Project	IEEE 802.16 Broadband Wireless Access Working Group < http://ieee802.org/16 >	
Title	Enhancements to reporting structures within WirelessMAN-CX	
Date Submitted	2006-02-28	
Source(s)	Paul Piggin Cygnus Communications 2075 Las Palmas Drive Carlsbad CA 92009	Voice: 760 448 1984 Fax: 760 448 1989 ppiggin [at] cygnuscom.com
Re:	Call for Contributions, IEEE 802.16h Task Group on License-Exempt Coexistence, IEEE 802.16h-06/005	
Abstract	This document contains suggested enhancements to the working draft and base standard to facilitate a framework from which MAC enhancements for license-exempt and uncoordinated system operation can be developed.	
Purpose		
Notice	This document has been prepared to assist IEEE 802.16. It is offered as a basis for discussion and is not binding on the contributing individual(s) or organization(s). The material in this document is subject to change in form and content after further study. The contributor(s) reserve(s) the right to add, amend or withdraw material contained herein.

Enhancements to reporting structures within WirelessMAN-CX

Paul Piggin
Cygnus Communications Inc.

Figure [abcd] – Flowchart showing generic operation in bands with specific spectrum users

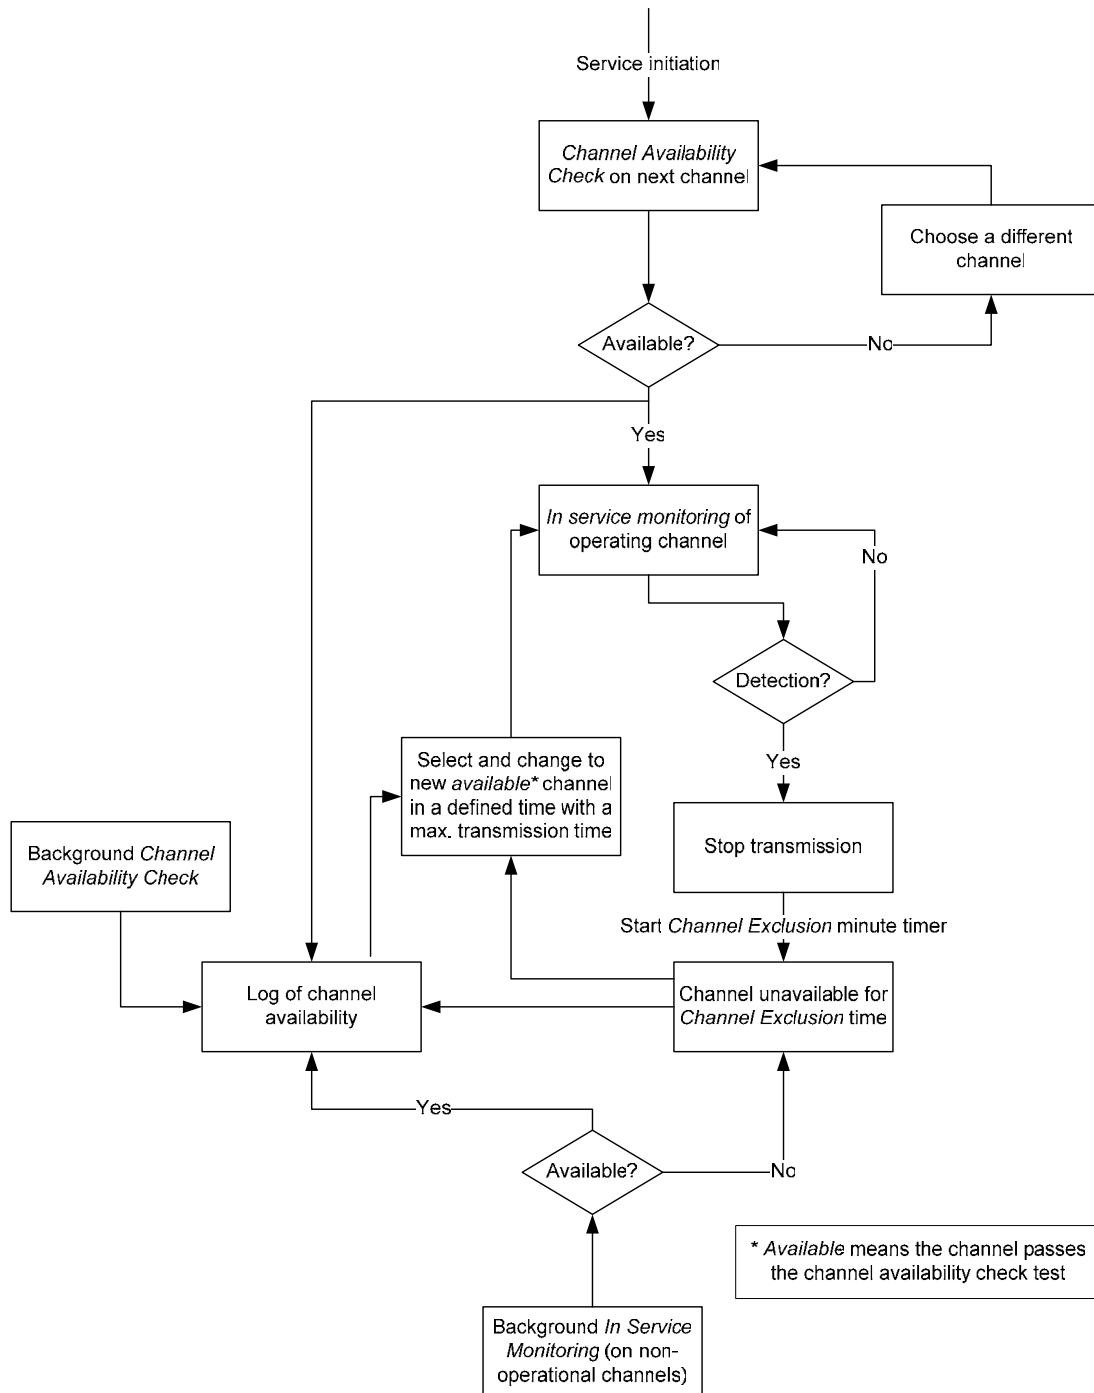
Add the following text at the end of section 6.3.15.1.

Figure [abcd] provides a flowchart representation of a generic scheme for operation in bands with specific spectrum users. WirelessMAN-CX provides enhanced reporting for specific spectrum users and addresses the need in situations where more than one type of specific spectrum user is operational in a given band.
